RANCHO PALOS VERDES

TO: CAROLYN LEHR, CITY MANAGER
FROM: RAY HOLLAND, DIRECTOR OF PUBLIC WORKS
DATE: JUNE 29, 2011
SUBJECT: WEEKLY ADMINISTRATIVE REPORT

LADERA LINDA

City of Rancho Palos Verdes Draft Working Doc.

Enclosures

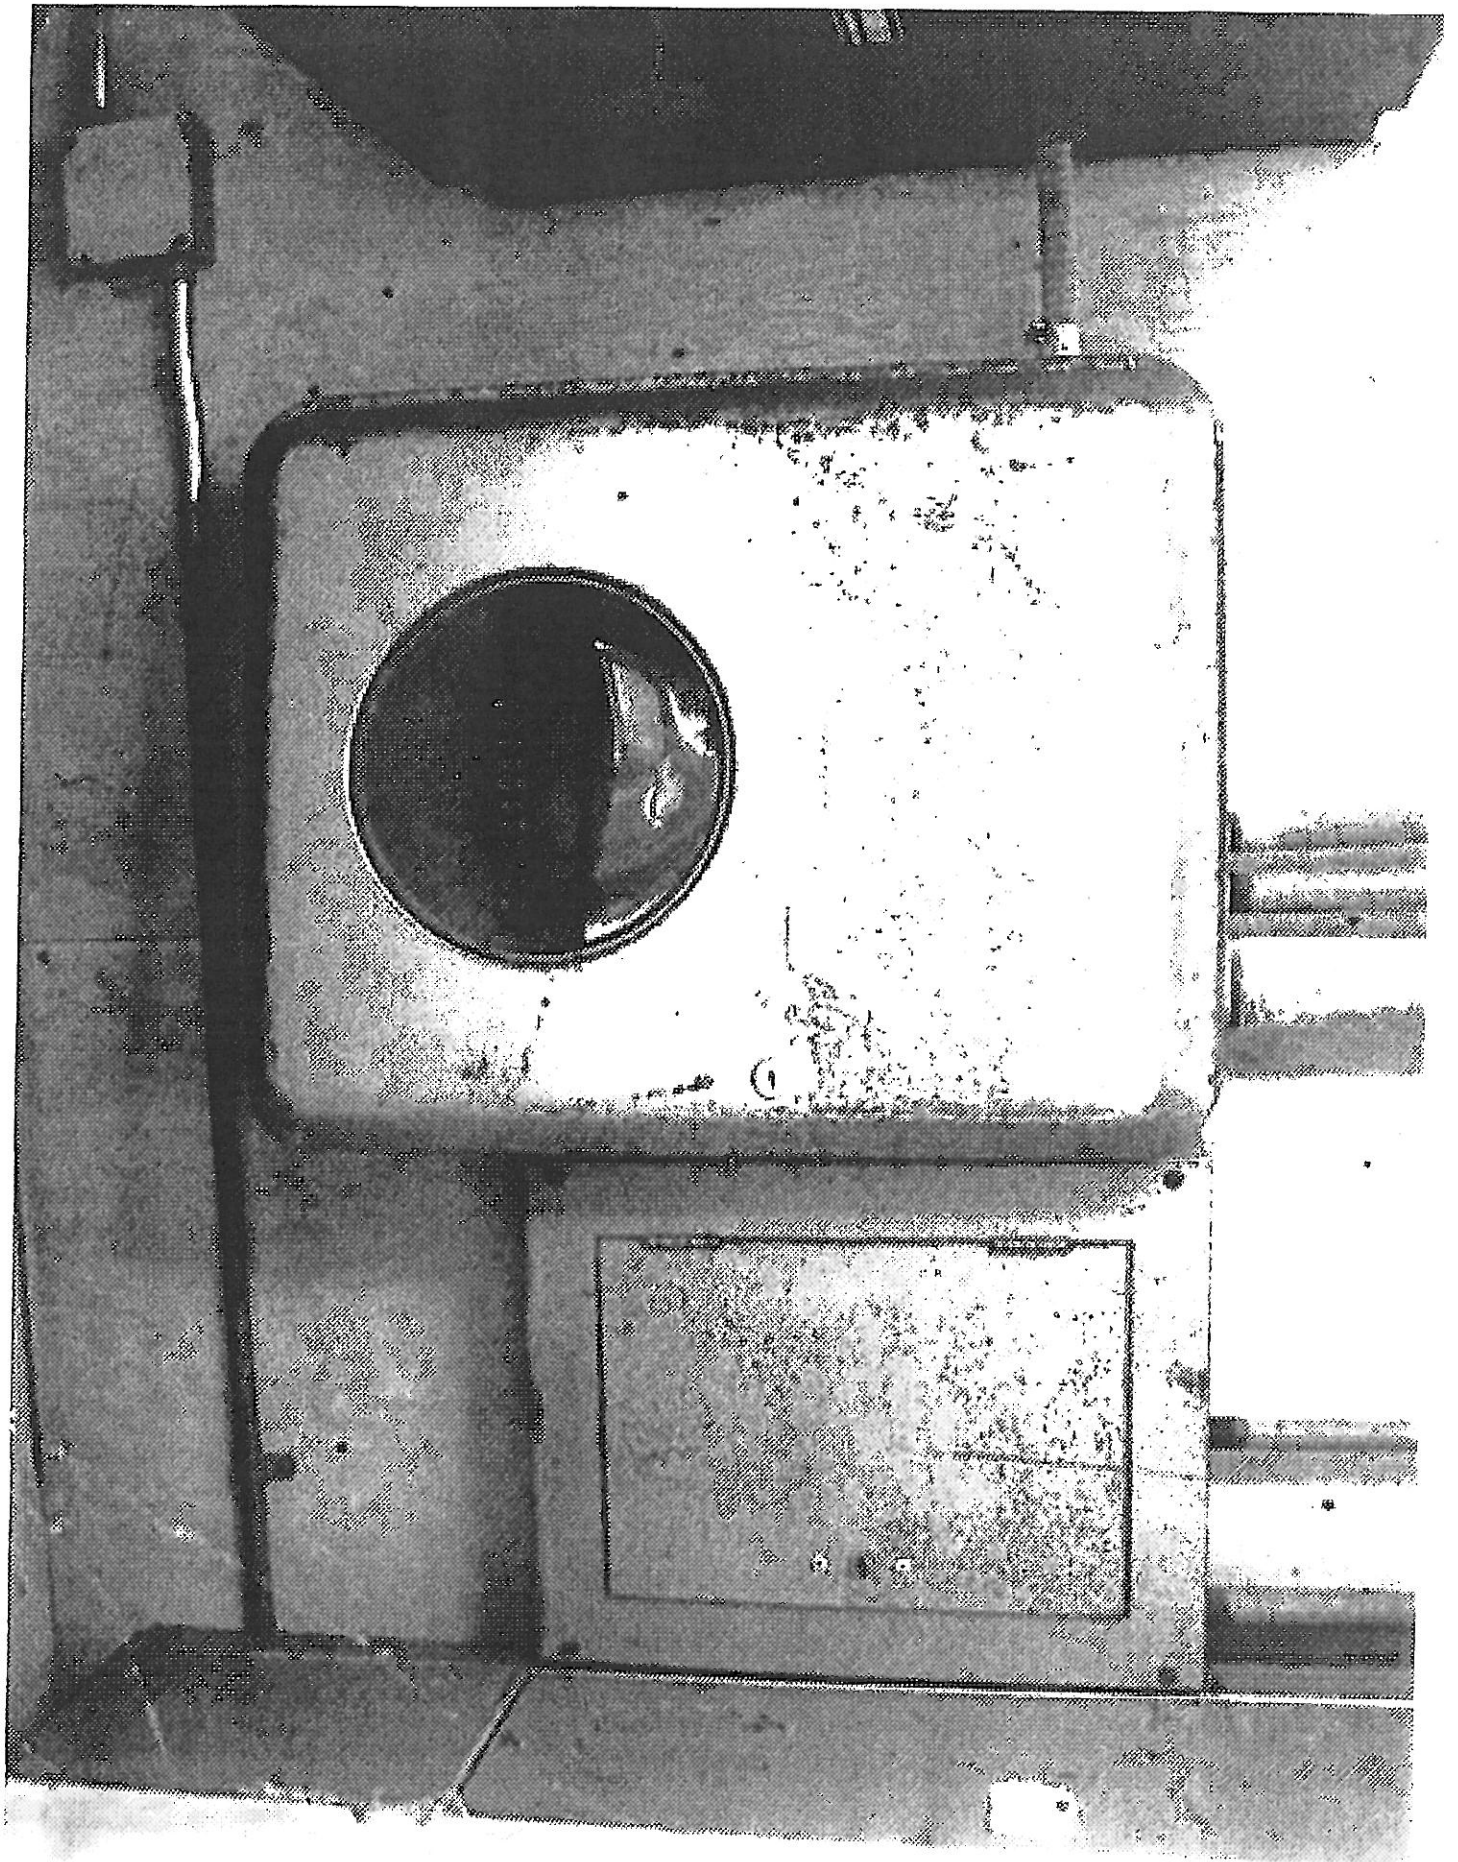
<p>The valley/bowl locations of this site makes it prone to mudslides and drainage issues from the adjacent hillsides. (This condition affects the upper road areas leading to the hiking areas).</p>	<p>The grounds and the buildings for their age, and given the sites location in the salty ocean air, are very well maintained. The same can be said for the interiors of the buildings we went through.</p> <p>Site pad. The facility sits above a residential neighborhood towards the ocean. The embankment between them is an irrigated landscape, with a series of "V" ditches horizontally, and looks very stable in terms of erosion. The embankment on the opposite side, from the parking lot up to Forrestal Drive, also seems to offer protection to the site. On site the storm drains appear to be well located in terms of placement and elevation. A good portion of the storm water runoff from the playground / parking area terrace above flows down to the Ladera Linda parking lot. This parking lot appears to be in fair condition, and will need resurfacing in the near future. It seems to have good drainage. It is vital that the storm drains and irrigation systems continue to be well maintained.</p>

<p>The building is not weatherproof in some areas, since the irrigation system this corroded the exterior wall panels. (Wall panels have been patched or replaced).</p>	<p>Structures. The buildings appear to be a prefabricated, assembled on site, interlocking metallic panel constructed, school class room type units. Each rectangular shaped unit consists of one long and two short - more or</p>

<p>Current construction does not comply with current seismic, fire/life-safety requirements. (This was not required at the Time/Date of original construction).</p> <p>Portions of new storage area additions are not fire resistive or 1 hour construction. (Condition remains on the addition area. The detached shed building will be relocated).</p> <p>Door heights of less than 6'8" high in building B (Conditions still remain).</p> <p>Fire/Life Safety: No fire sprinklers. (This was not required at the Time/Date of original construction).</p>	<p>less solid walls (with short, high windows in the rear long wall), and a front wall composed of windows and doors across the majority of it. The roof extends as an owning cover, over the front wall.</p> <p>Some of the panels have been patched, and an occasional vertical trim piece (located between each panel) is coming loose. One such trim piece moved enough to show that the panels do have an interior connection between them, yet it is hard to know how important a connective value the screws on both sides of these vertical trim pieces play, in holding the buildings together structurally. And although the building exteriors are routinely painted, it is as difficult to know how well the vertical and horizontal exterior fasteners have maintained their strength over the years in the weather, as it is to know how well the walls are anchored to their foundations. Yet the front walls, by their very openness in terms of wall area, appear weak in terms of shear.</p> <p>The fencing around the electrical service equipment area has significant dry rot damages around its base.</p> <p>From the stairs to the play equipment yard above, the roof on building "J" and "K" looked to be in good condition.</p>

<p>Accessibility: No approved fully accessible restrooms exist. Missing ramps from the classroom doors to outdoor areas on the west side. The required door edge side strike clearance is not a minimum of 18" on the pull side of 12" on the push side at some of the doors. No lever hardware on the doors. Over ½" high door thresholds. Excessive slope at the ramp to the lower play yard. No ramp or lift to upper play yard. (Construction work with a 2011 valuation of \$132,536.28 or more triggers accessibility upgrades).</p>	<p>The classroom type buildings, restrooms, and grounds are existing, nonconforming in terms of accessibility.</p>

<p>Added west facing exterior doors leading to the play yard areas open up over a step down. Improper size landings were installed and no ramps were installed. Interior doors were installed that are less than 6'8" tall.</p> <p>Missing required door landings on the exterior side of building B. (Condition still remains).</p>	
<p>Electrical service is exposed to the weather and is located in areas subject to flooding. (Overhead roll up door must be kept closed to prevent weather exposure).</p> <p>Some of the sub panels have "Pushmatic" breakers which have been listed on a product alert or recall from the Consumer Product Safety Commission. (New breakers and sub panel was installed).</p> <p>Extension cords are being used as a substitute for permanent building wiring. (Condition changes based on tenants needs, Education on the use of cords or additional outlets can be provided).</p> <p>The electric conduit has corroded on the west side of the building where it rises from below the ground repaired with roof sealing material. (Condition was not found to be hazardous; upgrade/replacement of electrical utilities is anticipated).</p>	<p>Electrical. The electrical service, from the outside appears rusted, and is exposed to the atmosphere. It may well be that the electrical connections and components inside are deteriorating as well. The sub panels are antiquated. The sub panels in rooms "J" and "K" are labeled in a contradicting fashion. One roistered with "X-1" crossed out and with "D-1" next to it, indicating the panel disconnect at the service equipment The other showing both circuit breakers could be the disconnecting means. Receptacle placement is sparse- the office area receptacles look over loaded, with numerous cords plugged into them. The panel and circuit breakers in the custodial closet have no labeling, and projection from the wall intrudes on its working space. It appears that the whole electrical system is nearing or has reached the point needing replacement.</p>

<p>Leaking and deteriorating gas, waste, and water lines. (Conditions remain. Use of gas piping has been discontinued).</p> <p>Missing earthquake straps for the water heater(s). (Electric water heater installed with seismic straps).</p> <p>The water heater t&p drain needs to be run to the exterior of the building. (Electric water heater installed on the exterior).</p>	<p>Plumbing. It sounds as though a portion of the building sewer has been relined, yet that problems remain with both the building sewer and drain systems, both of which perhaps are nearing or have reached the point of replacement. It appears that the water piping was plumbed with copper pipe in the bathrooms, visible from an access panel in the custodian's closet. No signs of leaking were observed. The condition of water piping underground is unknown. The bathrooms have accessibility issues. Per the city report, the water heaters are non compliant in terms of earthquake strapping, and pressure temperature relief valve piping. Those units</p>

<p>The water supply shut off valves are not operable at many areas. (Conditions remain but new plumbing work has operable valves).</p> <p>Water to added preschool toilets was connected to irrigation line and also without a separate shutoff valve. (Condition remains).</p>	<p>out of site of their electrical panels, had no disconnect. Also per the city report, the bathrooms, and classroom sinks have accessibility issues.</p>
<p>The heating systems in the classrooms are very old and the flames were not all blue. This might indicate that there is a hazard of carbon monoxide which should be checked out by a gas company representative. (Use of gas heaters has been discontinued).</p> <p>The mechanical and electrical equipment is not seismic braced. (This was not required at the Time/Date of original construction).</p>	<p>Mechanical. The forced air heating equipment on site is original, and most likely so inefficient that it isn't worth repairing. The "temporary" electrical heaters are too small to provide comfort in the classrooms, and perhaps should be removed as a safety measure.</p>
